CORRIGENDUM FOR NEW 1650 MTPD NPK PLANT AT FACT -CD, AMBALAMEDU ON LSTK BASIS

A. PROCESS

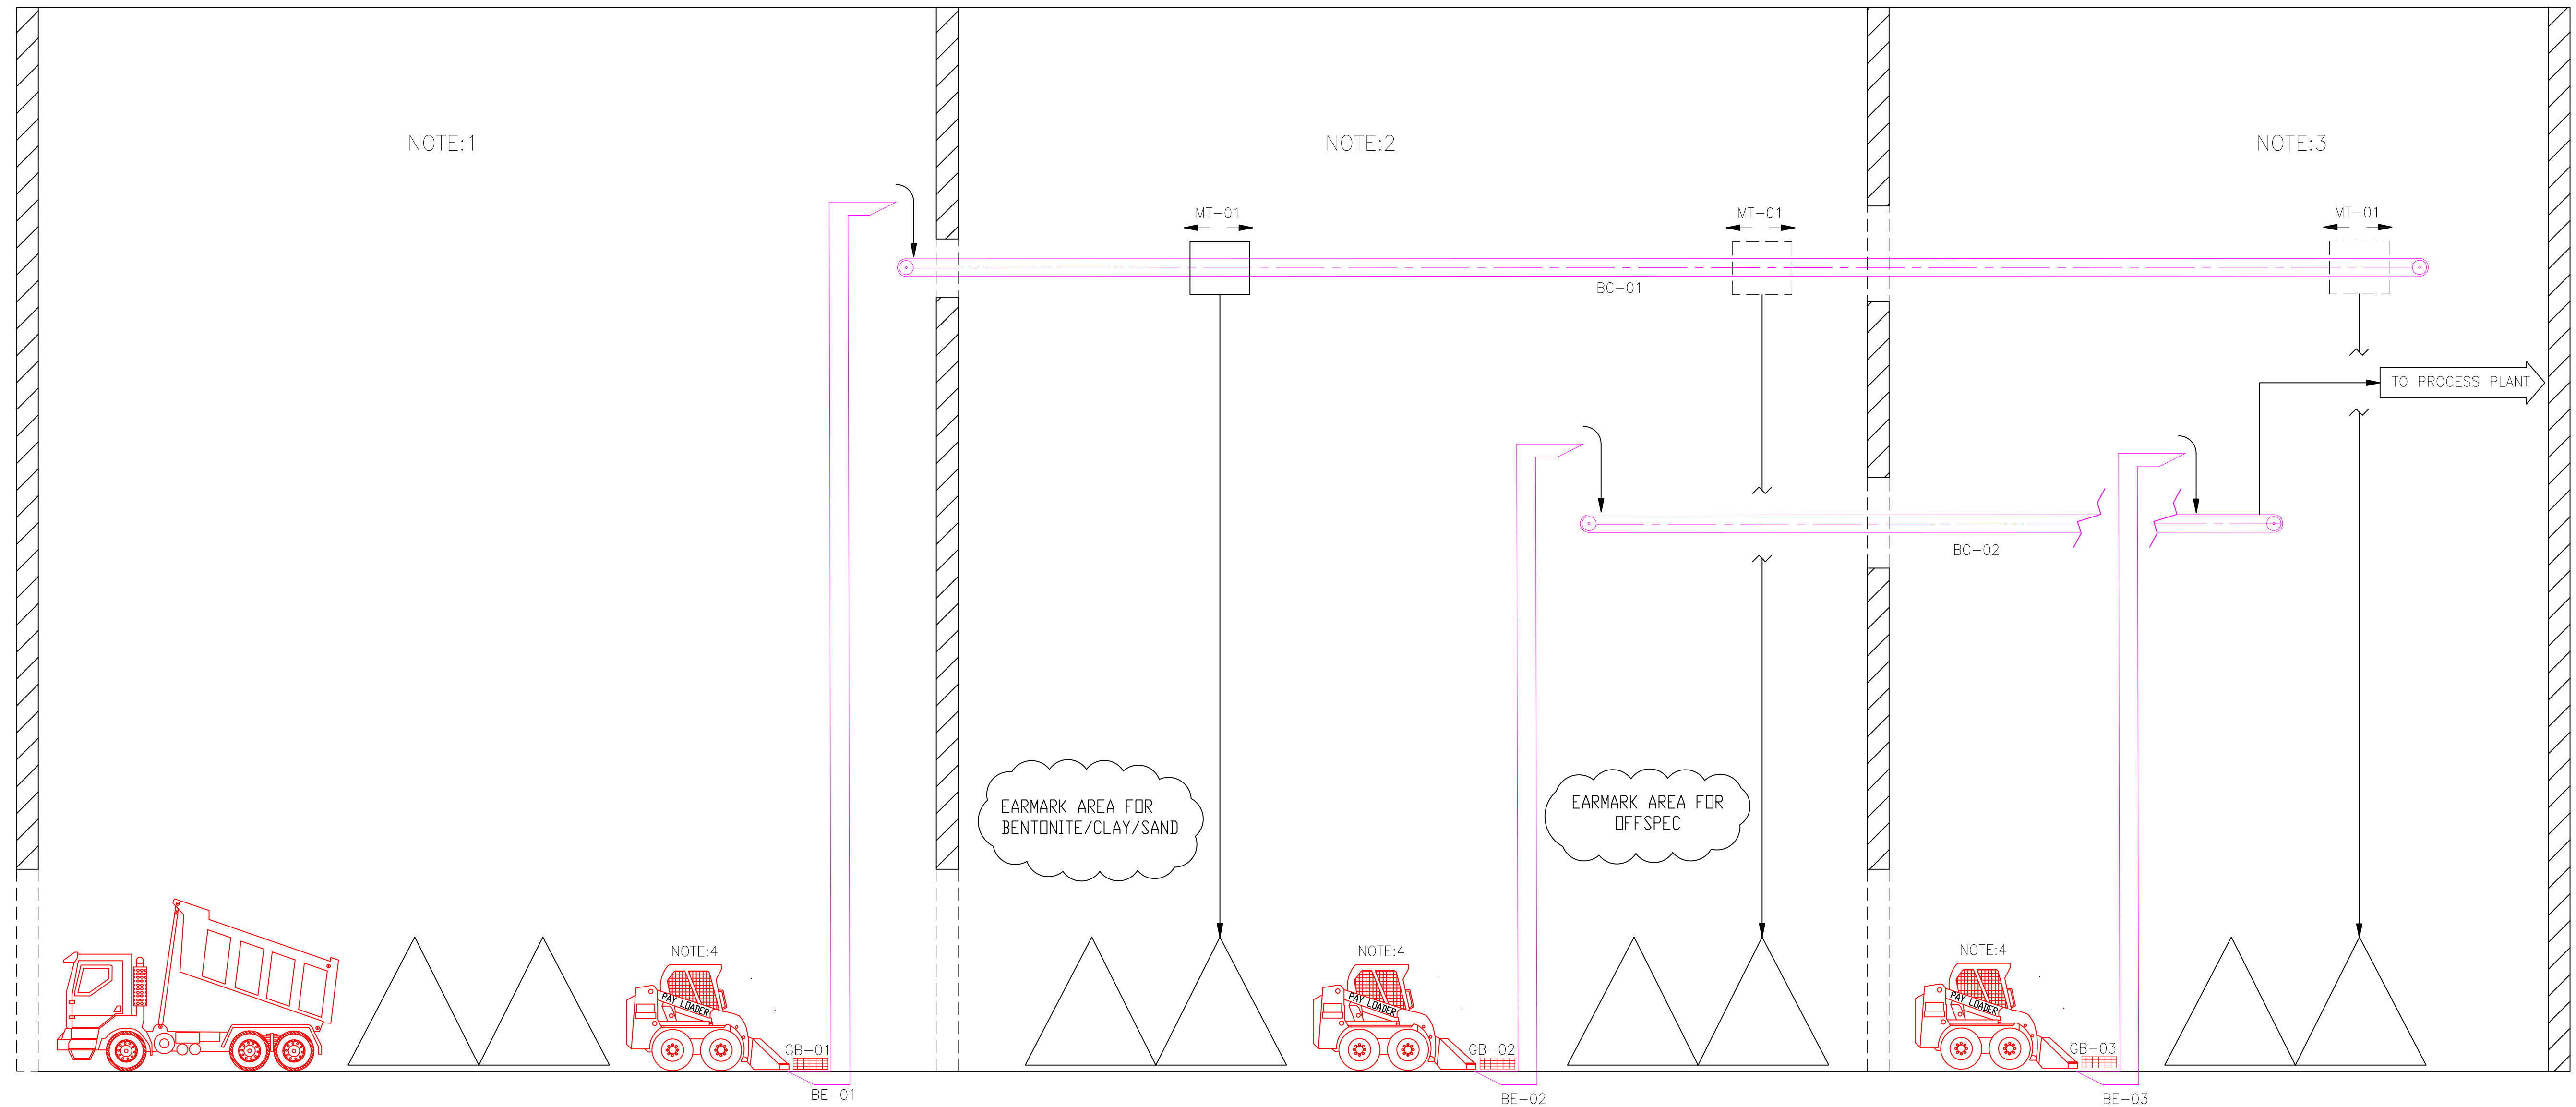
The revised drawing for schematic flow diagram for Product Handling Facility & Raw material handling facility is attached as annexure A2 to corrigendum.

DRG. NO. 32687-01-GA-00001

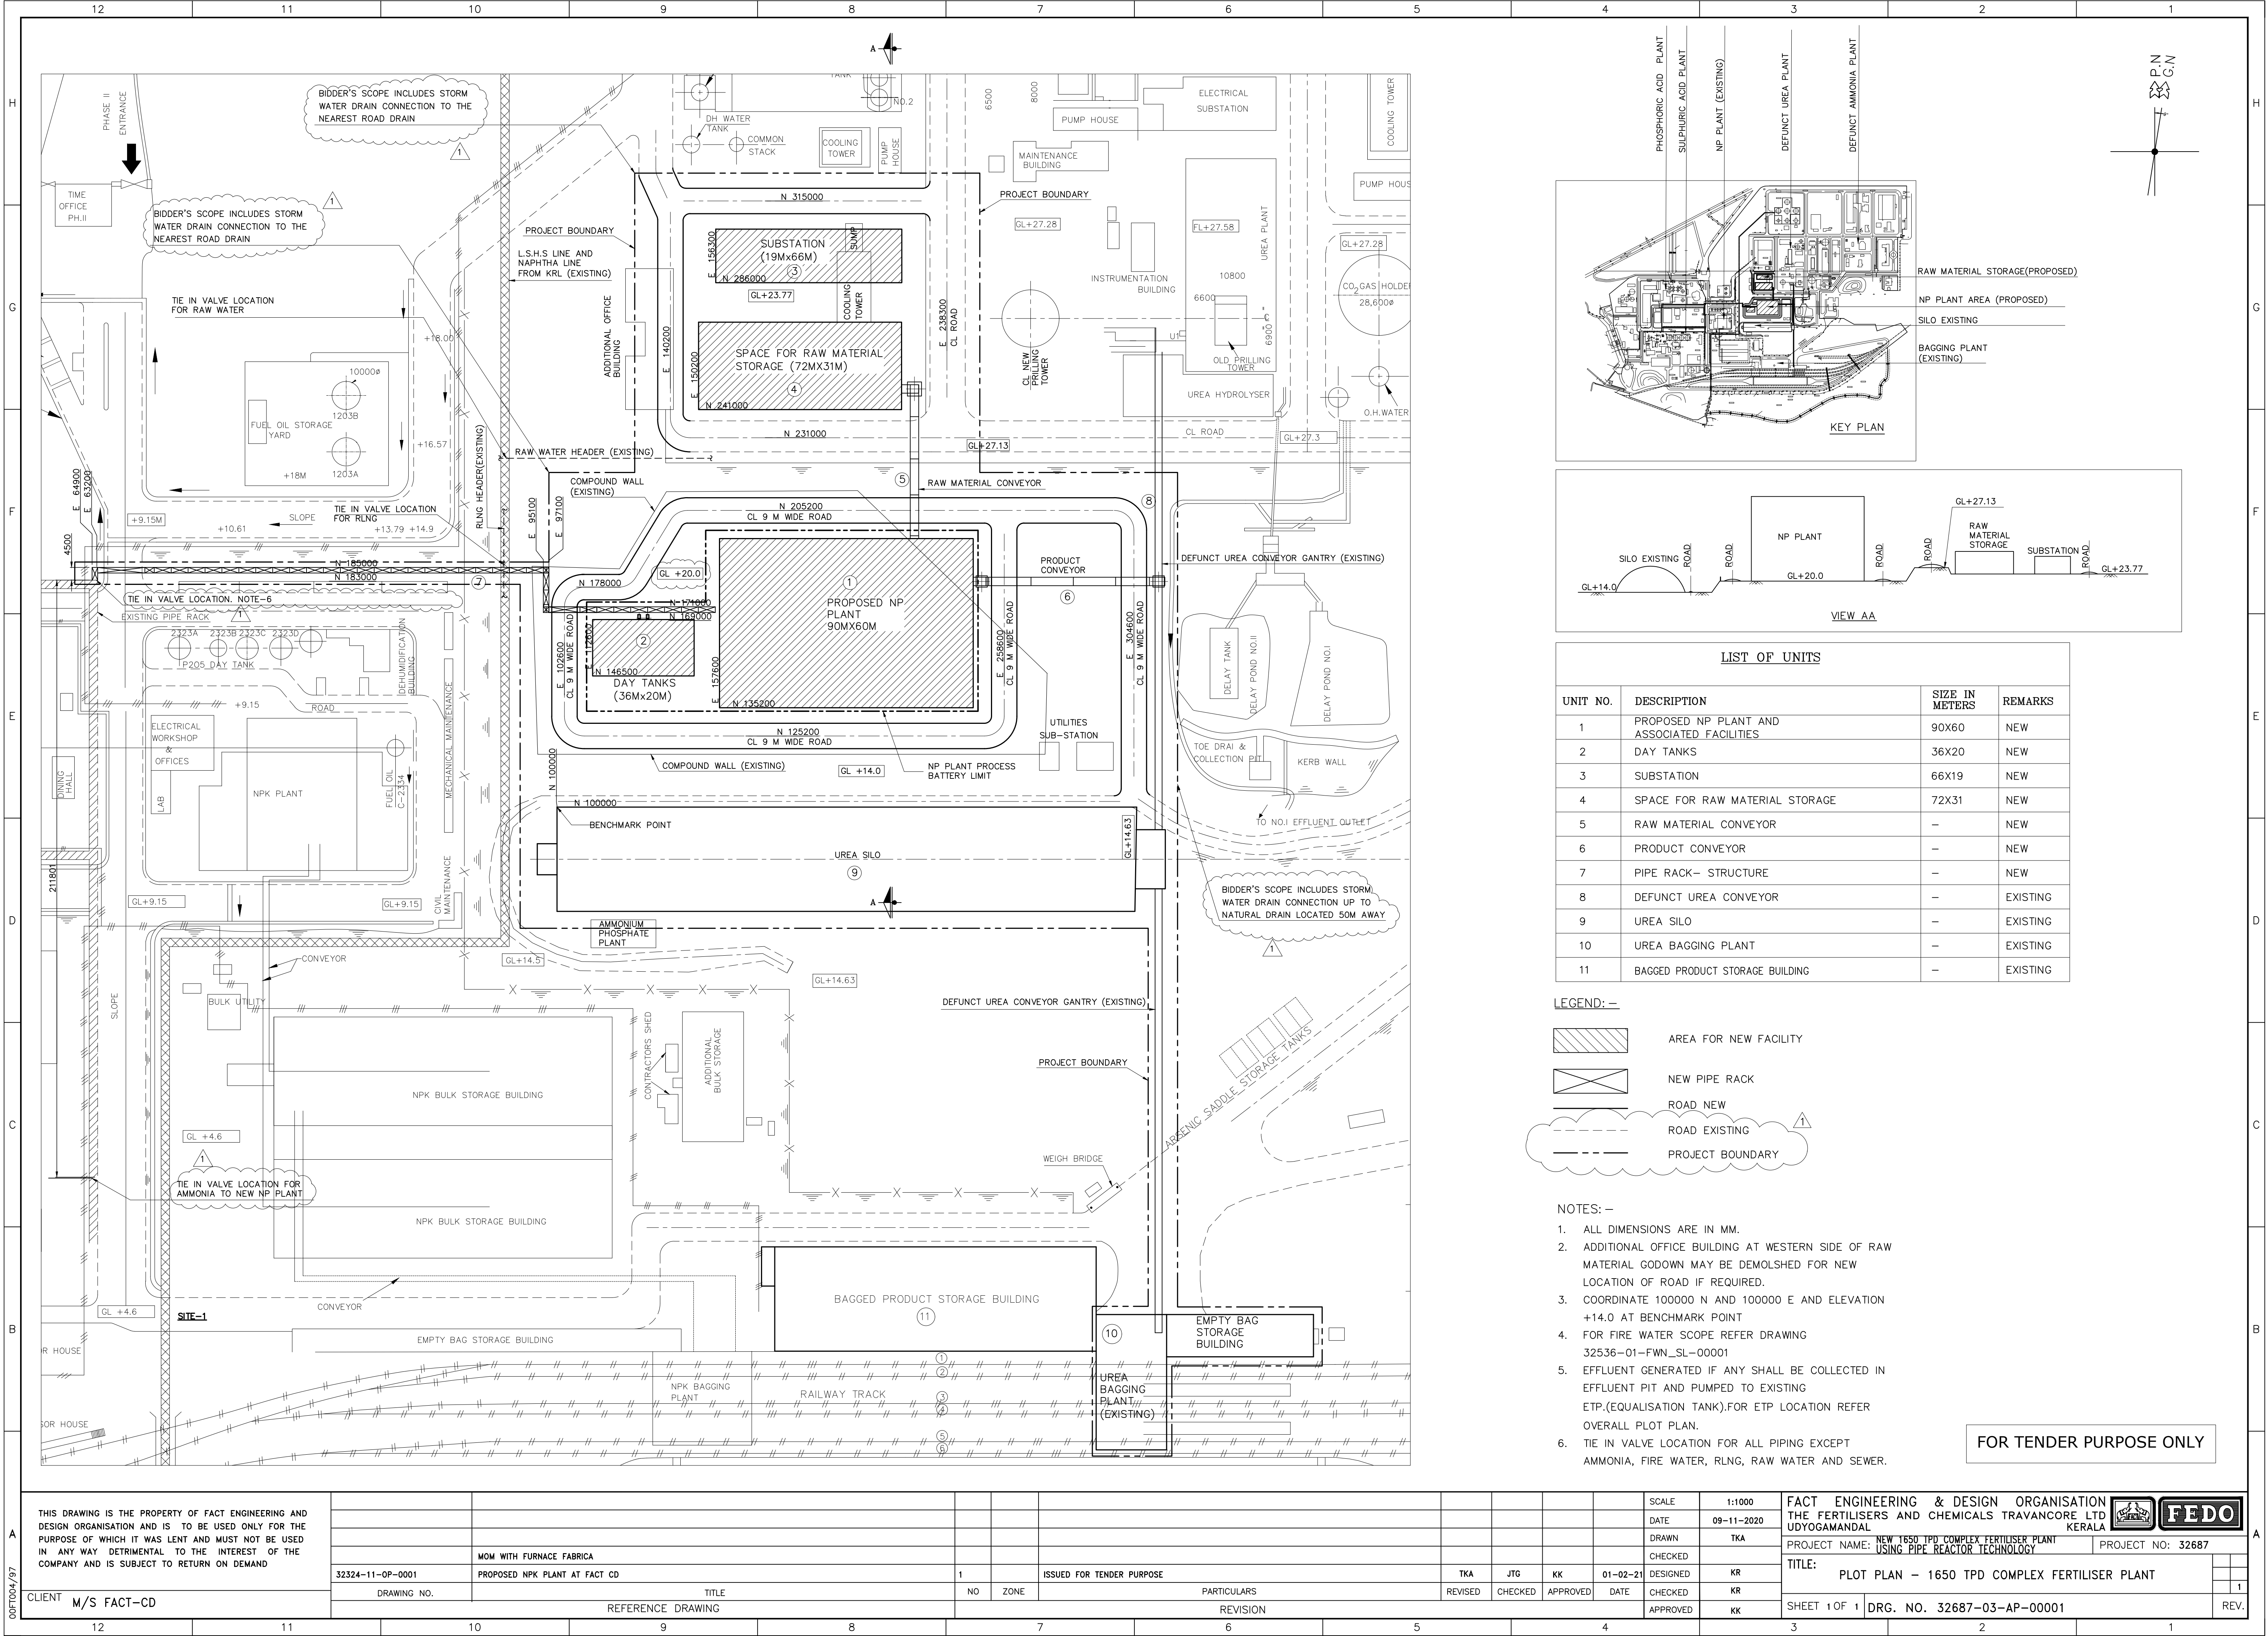
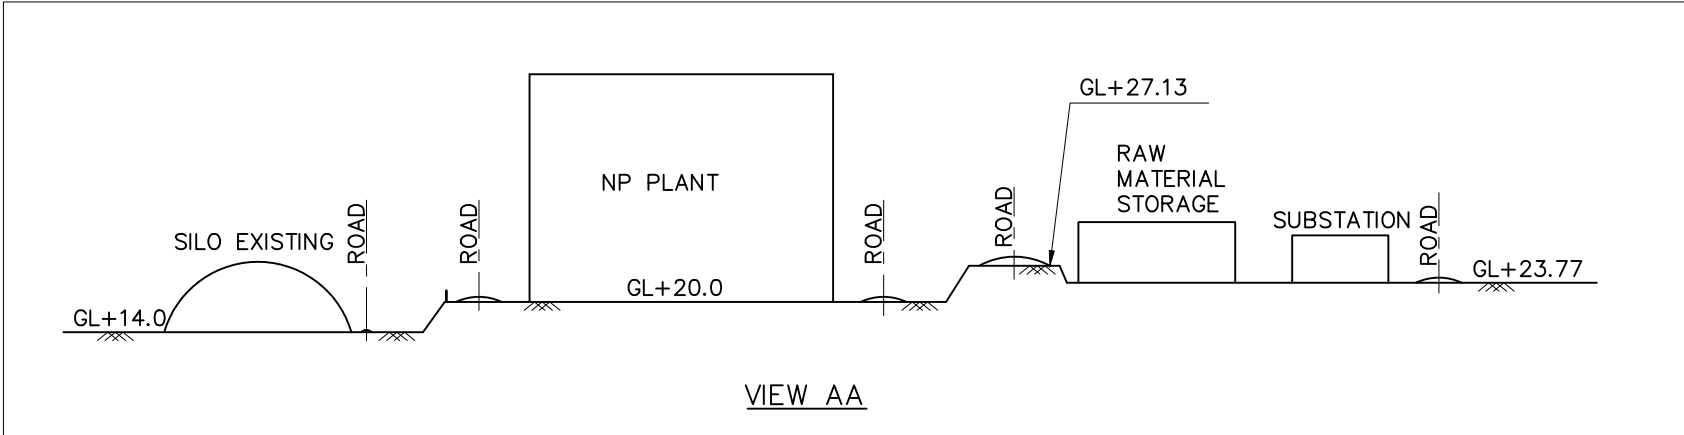
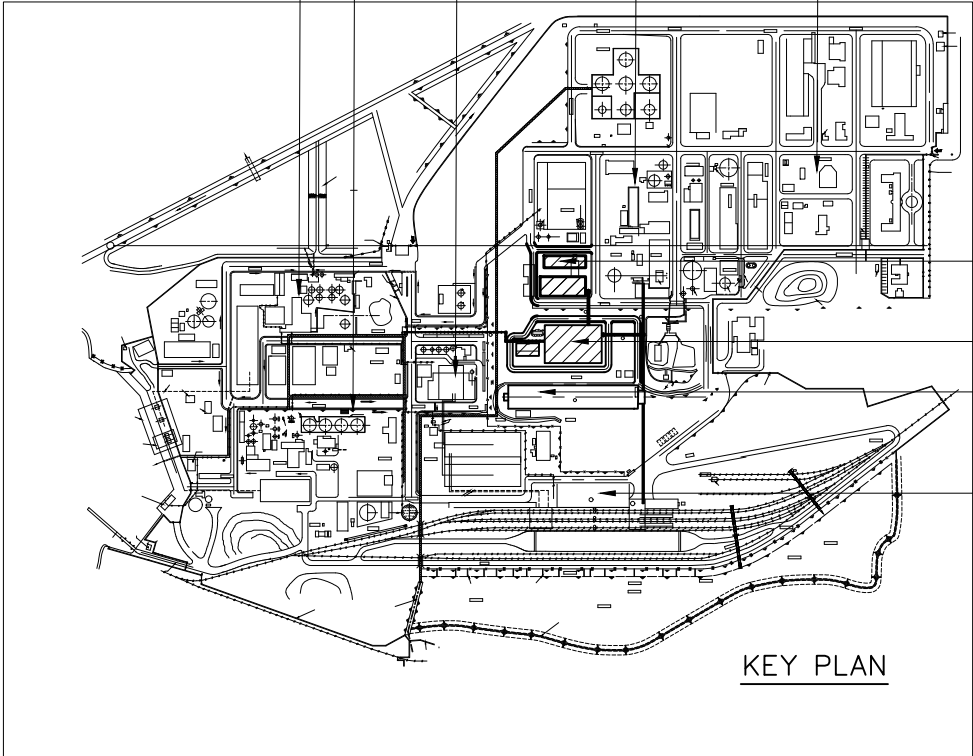
Additional requirement: GA Drawing with details of existing bunker outlet and height details are furnished with the corrigendum as **ANNEXURE C4**. If required, minor modification to the bunker outlet may be carried out to accommodate the duplex bagging machine.
